**SUBDIVISION,  
PLANNED UNIT DEVELOPMENT,  
ZONING AMENDMENT, &  
SIDEWALK WAIVER STAFF REPORT****Date: June 16, 2022**

<b><u>NAME</u></b>	WaWa, Inc.
<b><u>SUBDIVISION NAME</u></b>	Davis Pilot Family Subdivision
<b><u>LOCATION</u></b>	Southeast corner of Cottage Hill Road and Sollie Road
<b><u>CITY COUNCIL DISTRICT</u></b>	District 6
<b><u>PRESENT ZONING</u></b>	B-1, Buffer Business District and B-2, Neighborhood Business District
<b><u>PROPOSED ZONING</u></b>	B-2, Neighborhood Business District
<b><u>AREA OF PROPERTY</u></b>	2 Lots / 13.0 ± Acres
<b><u>CONTEMPLATED USE</u></b>	<p>Subdivision approval to create two (2) legal lots of record from three metes-and-bounds parcels; Planned Unit Development Approval to allow a unique sign package and shared access between two building sites; Rezoning from B-1, Buffer Business District and B-2, Neighborhood Business District, to B-2, Neighborhood Business District; and a Sidewalk Waiver request to waive construction of a sidewalk along Sollie Road and Cottage Hill Road.</p> <p><b>It should be noted, however, that any use permitted in the proposed district would be allowed at this location if the zoning is changed. Furthermore, the Planni

# SITE PLAN

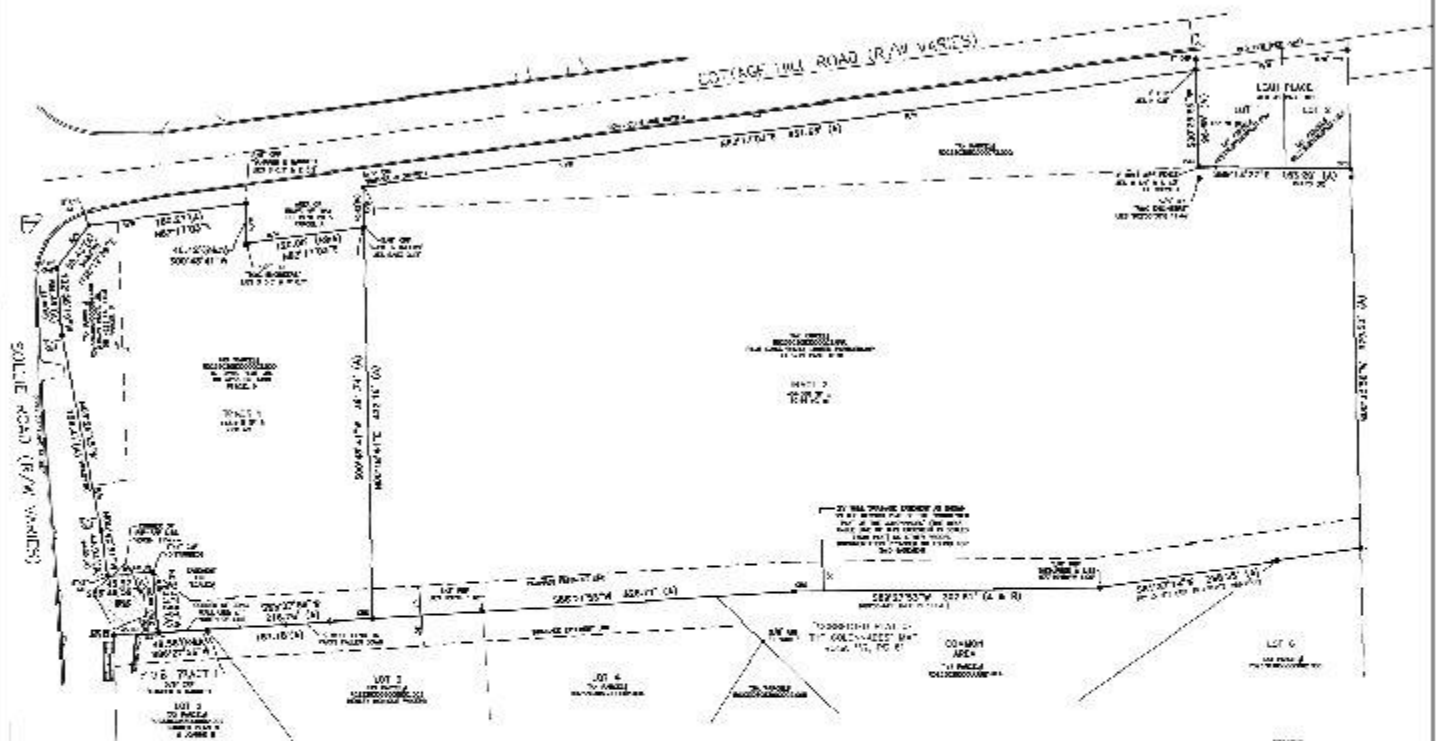
The lots fronts Cottage Hill Road and Sollie Road. Cottage Hill Road, is a minor arterial street, per the Major Street Plan, and as such should have a right-of-way of 100-feet. Sollie Road is a major collector street, per the Major Street Plan, and as such should have a right-of-way of 100-feet. The preliminary plat indicates both Cottage Hill Road and Sollie Road as having a rights-of-way that varies, therefore if approved, the Final Plat should be revised to either depict a compliant existing rights-of-way or to depict dedication to provide a minimum of 50-feet to the centerline of each street.

It should be noted that the preliminary plat does not depict the 25-foot minimum building setback for either proposed lot. If approved, the Final Plat should be revised to depict a 25-foot minimum building setback line along both street frontages.

The preliminary plat depicts an existing drainage easement at the rear of the site, as well as a proposed shared access easement on proposed Lot 2, for use by the proposed Lot 1. If approved, a note should be placed on the Final Plat stating that no structure is allowed in any easement, without the approval of the easement holder.

- 1) either depiction of an existing compliant right-of-way along Cottage Hill Road, or dedication to provide 50-feet to the centerline;
- 2) either depiction of an existing compliant right-of-way along Sollie Road, or dedication to provide 50-feet to the centerline;

# DETAIL SITE PLAN

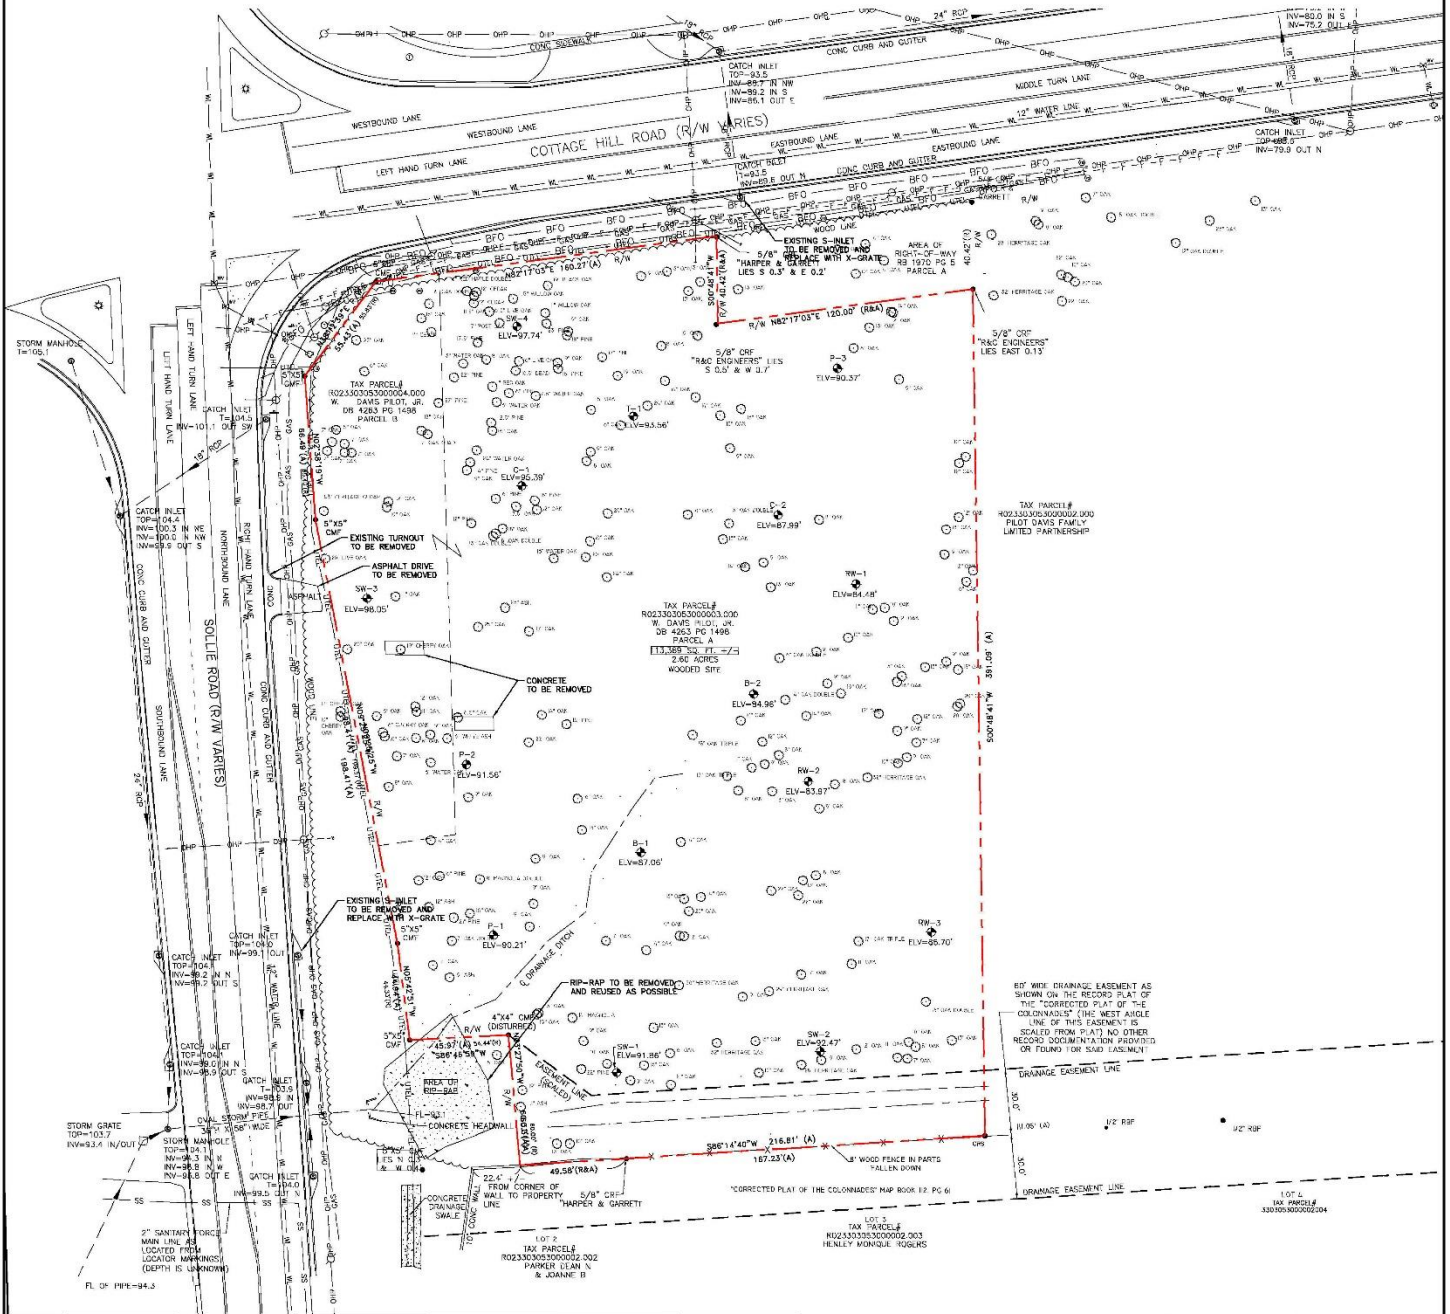
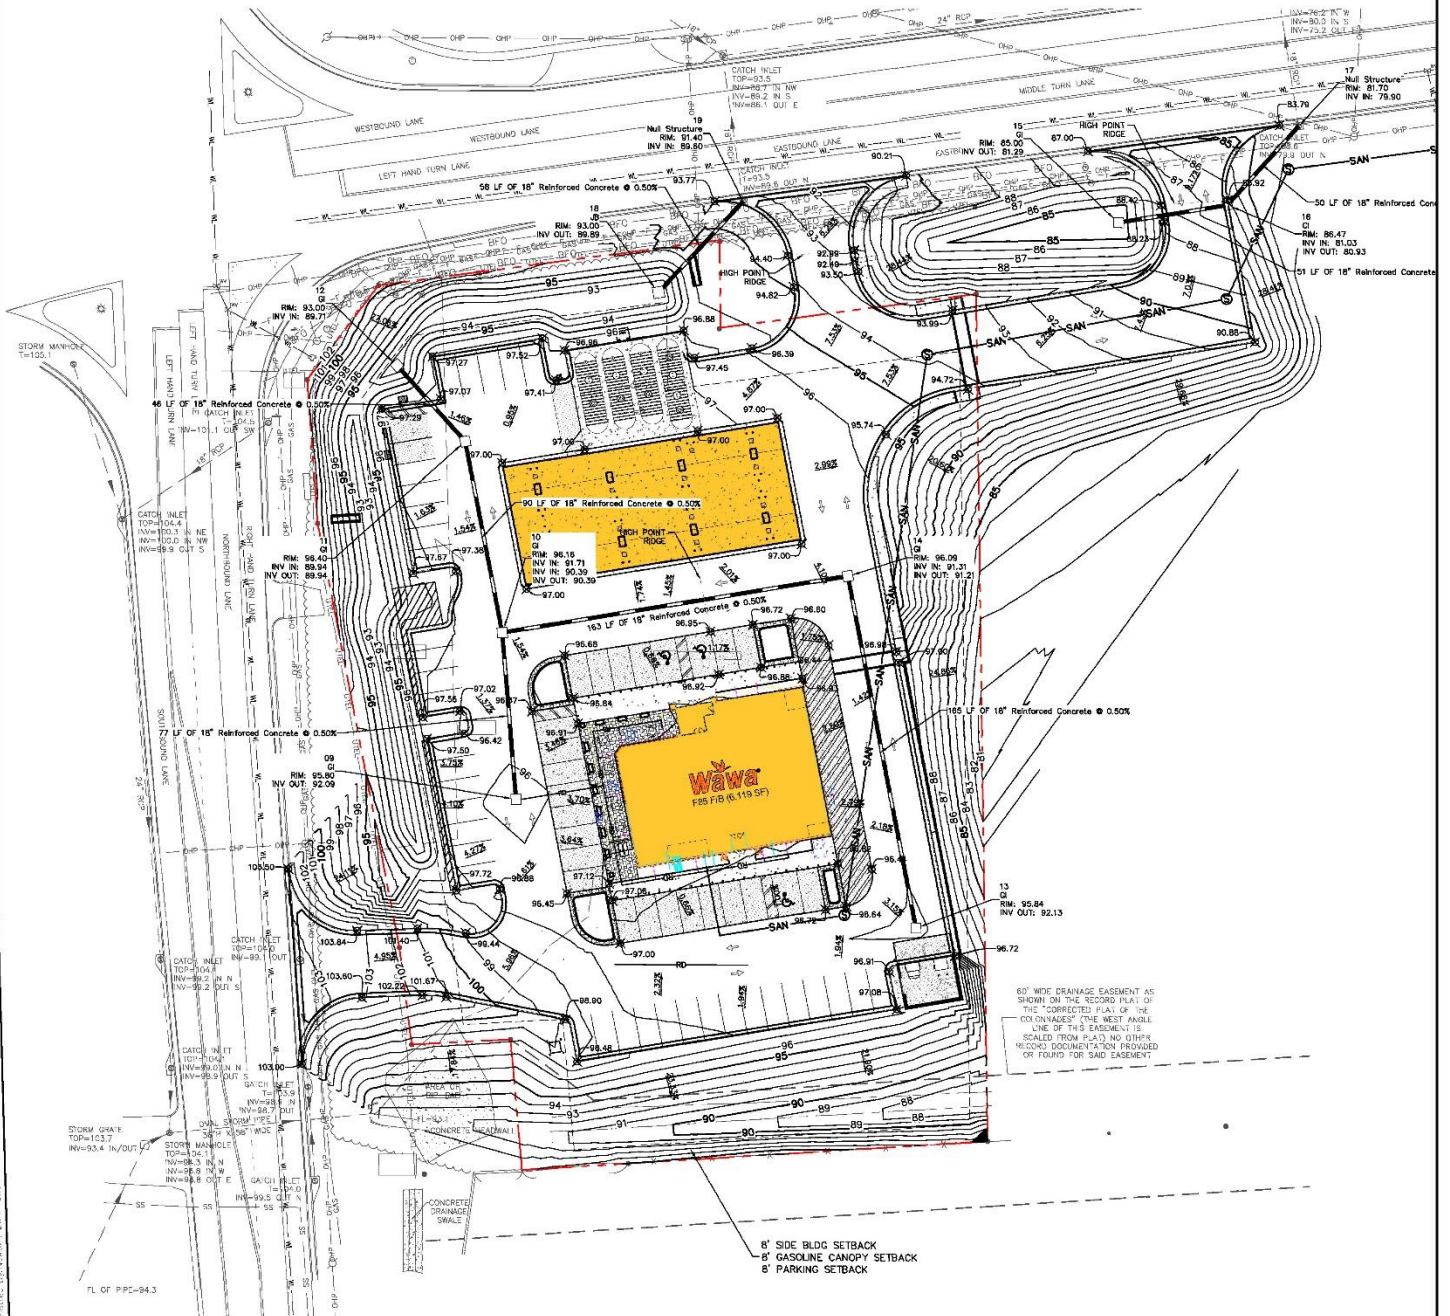
The site plan submitted depicts a gas station on the proposed Lot 1, existing of a convenience store and gas canopy; with no development depicted on the proposed Lot 2. A shared curb cut for the lots is depicted, as well as a connection to Lot 2 and an additional curb cut to Cottage Hill Road. If approved, curbing or a similar barrier should be provided at the stub out to prevent vehicular access to the adjacent undeveloped lot. It should also be noted that a new Planned Unit Development will be required at the time of development for Lot 2.

The site plan submitted shows all proposed structures meeting required minimum setbacks. The proposed convenience store is 6,119± square feet, and as such, requires a minimum of 21 parking spaces; 63 parking spaces are depicted. As the site will have more than 25 parking spaces, a compliant photometric site plan will be required at the time of permitting, if approved.

- 1) either depiction of an existing compliant right-of-way along Cottage Hill Road, or dedication to provide 50-feet to the centerline;
- 2) either depiction of an existing compliant right-of-way along Sollie Road, or dedication to provide 50-feet to the centerline;
- 3) provision of the lot sizes in square feet and acres, adjusted for dedication;
- 4) maintenance of a compliant residential buffer along the South property line;
- 5) provision of a compliant photometric site plan at the time of permitting;

**A** 30" / 3 PRODUCT  
CUSTOM P-150 D/F ILLUMINATED PYLON SIGN (171.44 SQ. FT.) - QTY: 2

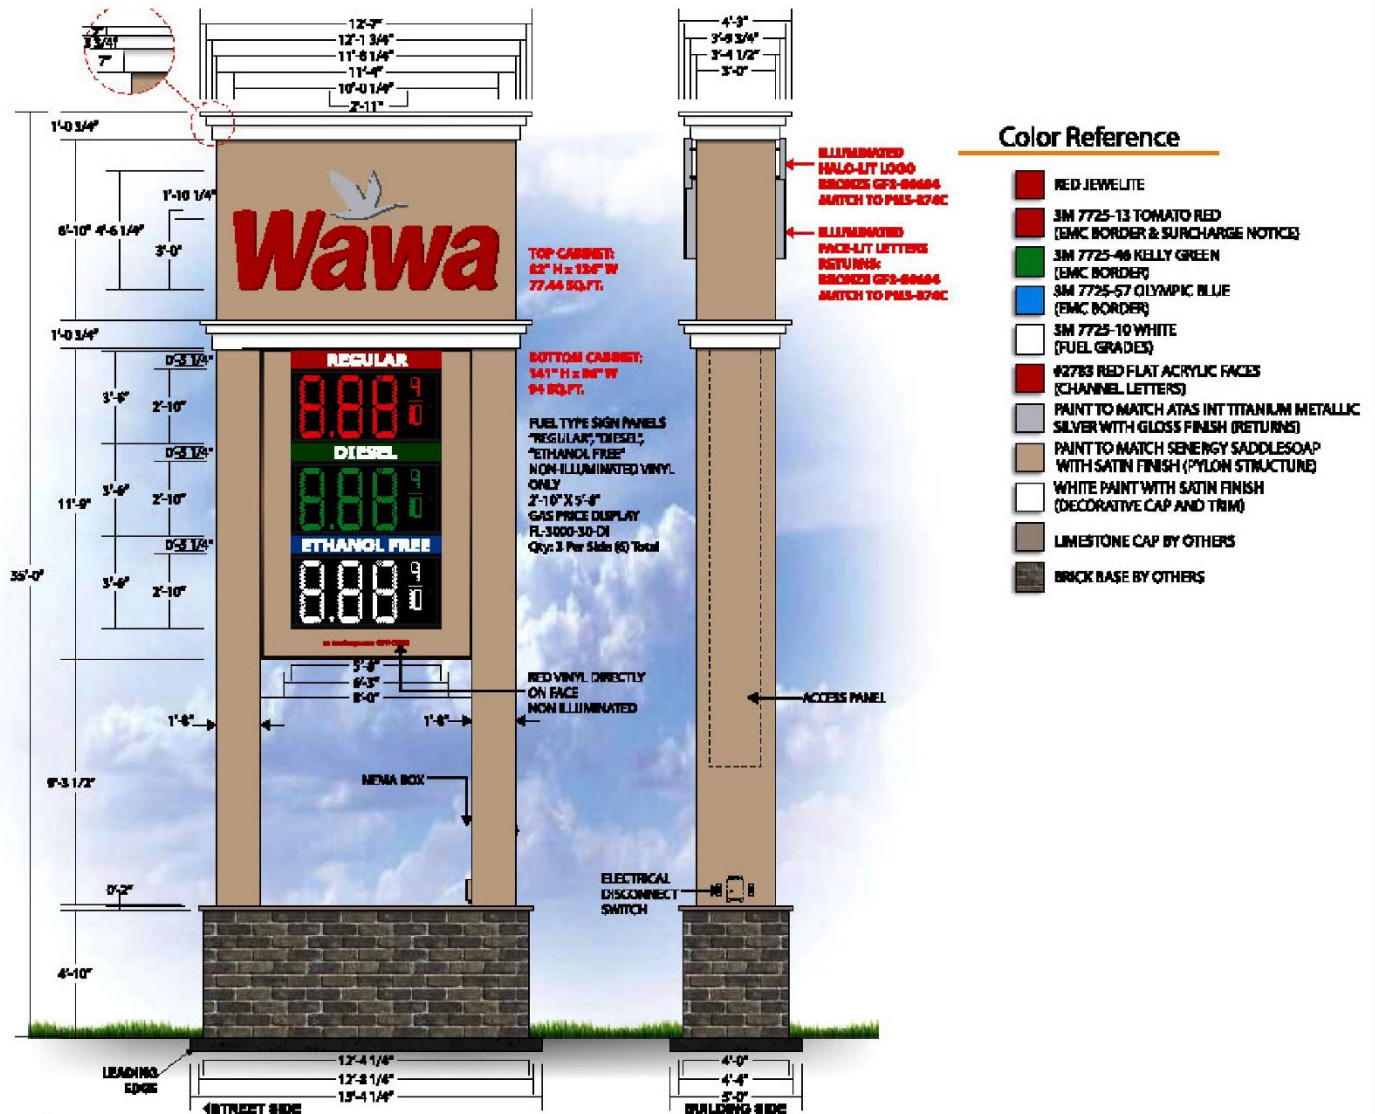
The applicant is requesting a unique sign package rather than the standard Zoning Ordinance allowance. A total of two (2) freestanding, four (4) wall, and three (3) canopy signs are requested for a total of nine (9) signs; the Zoning Ordinance allows a single business site a total of three (3) signs, with no more than one (1) freestanding sign. It should be noted that both of the proposed freestanding signs contain digital gas pricers, one of which may be located within 300' of residentially zoned property, which is prohibited by the Zoning Ordinance. If approved, the applicant should be advised that they will need to either insure the signage is more than 300' from residentially zoned property, or obtain a variance from the Board of Zoning Adjustment.

While it may be the applicant’s desire to have a unique sign package for their development, it should be noted that the Planning Commission has only allowed such allowances for large, multi-tenant developments, such as McGowin Park or Springdale Mall. This PUD is not proposing a comprehensive development plan for the entire PUD, thus the requested sign package seems unwarranted. Furthermore, approving an increase in signage from three (3) total signs to nine (9) would result in a cluttered site, and would set a precedent for other sites wishing to have an abundance of signage.

- 6) development of the site is limited to the standard sign allowances in the Zoning Ordinance for a single-business site;
- 7) full compliance with Engineering comments: (*ADD THE FOLLOWING NOTES TO THE PUD SITE PLAN: 1. Any work performed in the existing ROW (right-of-way) such as driveways, sidewalks, utility connections, grading, drainage, irrigation, or landscaping will require a ROW permit from the City of Mobile Engineering Permitting Department (208-6070) and must comply with the City of Mobile Right-of-Way Construction and Administration Ordinance (Mobile City Code, Chapter 57, Article VIII). 2. A Land Disturbance Permit application shall be submitted for any proposed land disturbing activity with the property. A complete set of construction plans including, but not limited to, drainage, utilities, grading, storm water detention systems and paving will need to be included with the Land Disturbance permit. This Permit must be submitted, approved, and issued prior to beginning any of the construction work. 3. Any and all proposed land disturbing activity within the property will need to be submitted for review and be in conformance with Mobile City Code, Chapter 17, Storm Water Management and Flood Control); the City of Mobile, Alabama Flood Plain Management Plan (1984); and, the Rules For Erosion and Sedimentation Control and Storm Water Runoff Control. 4. Any existing or proposed detention facility shall be maintained as it was constructed and approved. The Land Disturbance Permit application for any proposed construction includes a requirement of a Maintenance and Inspection Plan (signed and notarized by the Owner) for the detention facility. This Plan shall run with the land and be recorded in the County Probate Office prior to the Engineering Department issuing their approval for a Final Certificate of Occupancy. 5. The approval of all applicable federal, state, and local agencies (including all storm water runoff, wetland and floodplain requirements) will be required prior to the issuance of a Land Disturbance permit. The Owner/Developer is responsible for acquiring all of the necessary permits and approvals. 6. The proposed development must comply with all Engineering Department design requirements and Policy Letters.);*
